**FINAL DRAINAGE REPORT FOR
HIGH VIEW ESTATES
6665 WALKER ROAD
COLORADO SPRINGS, COLORADO 80908**

March, 2022
Revised May, 2022

PCD File No. MS-222

HIGH VIEW ESTATES
6665 WALKER ROAD
PROPOSED DRAINAGE PLAN

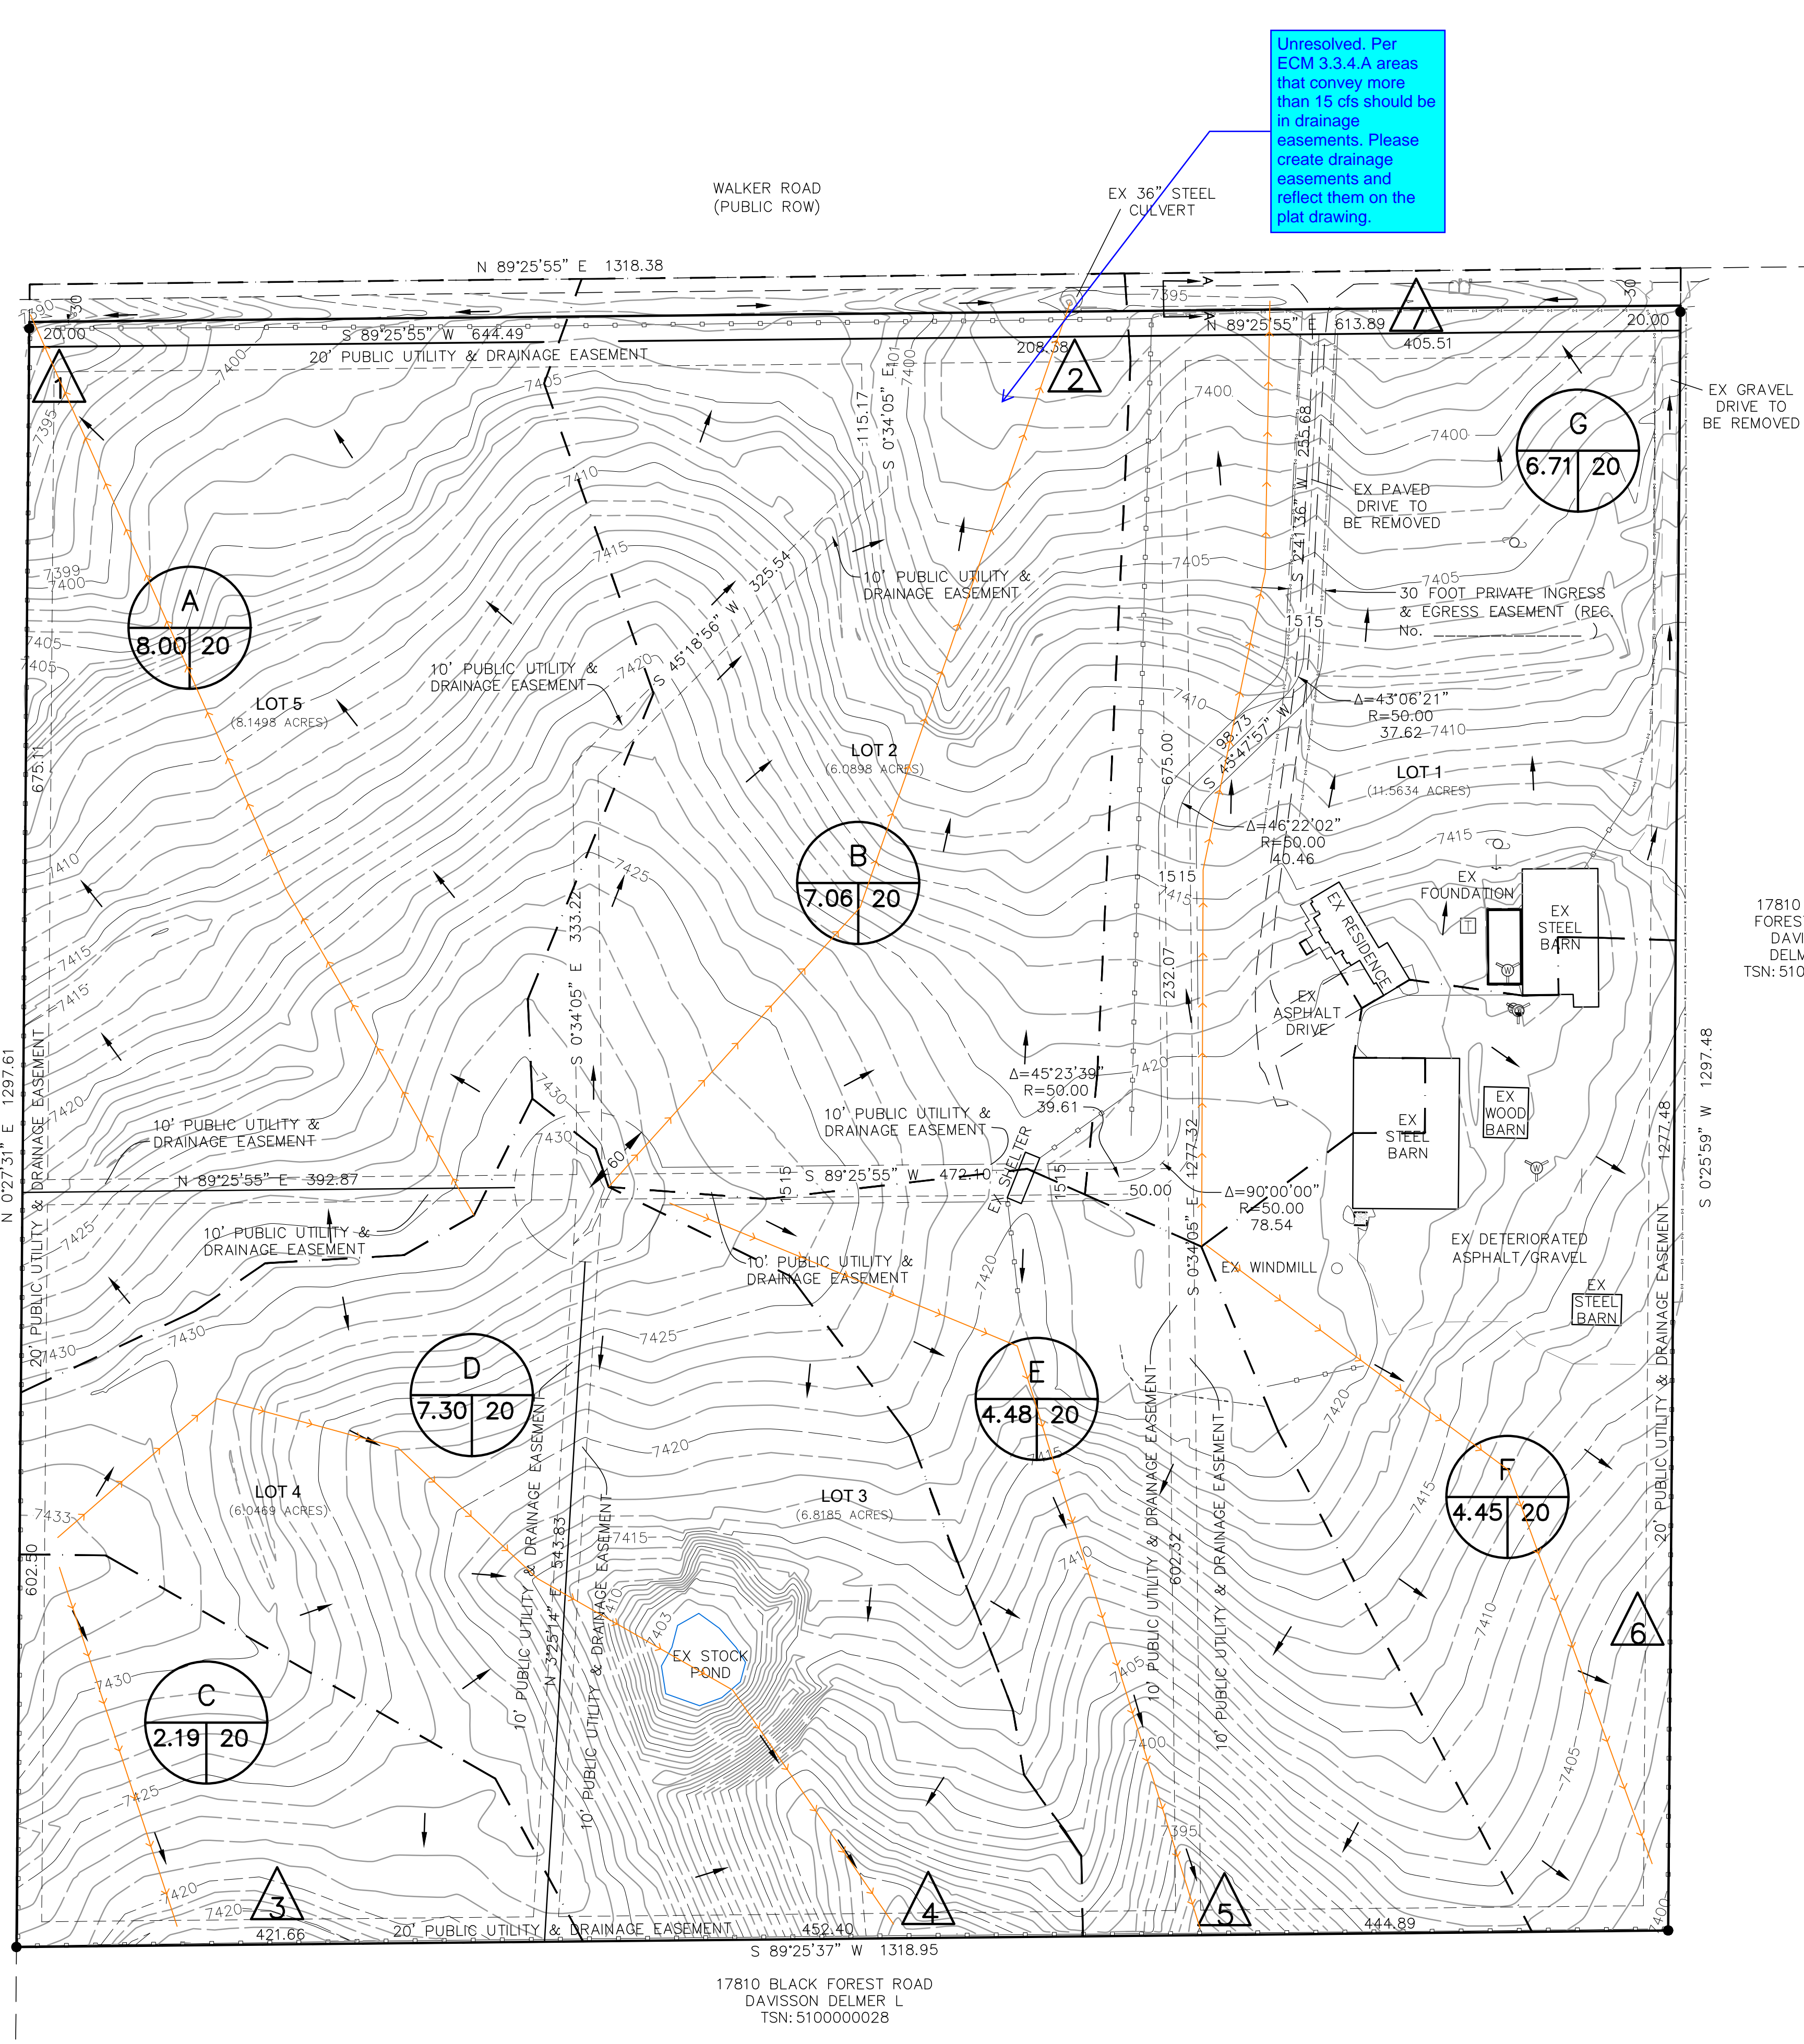
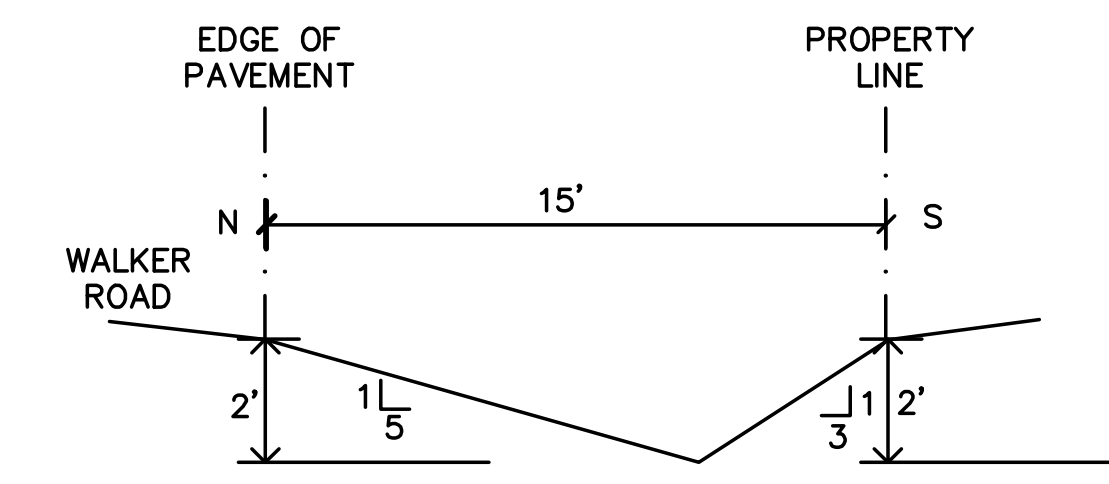
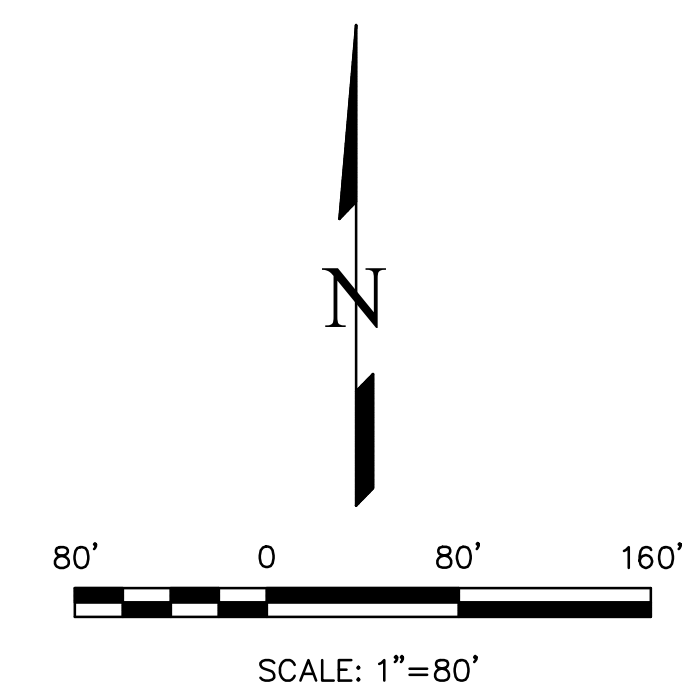
Unresolved. Per
ECM 3.3.4.A areas
that convey more
than 15 cfs should be
in drainage
easements. Please
create drainage
easements and
reflect them on the
plat drawing.
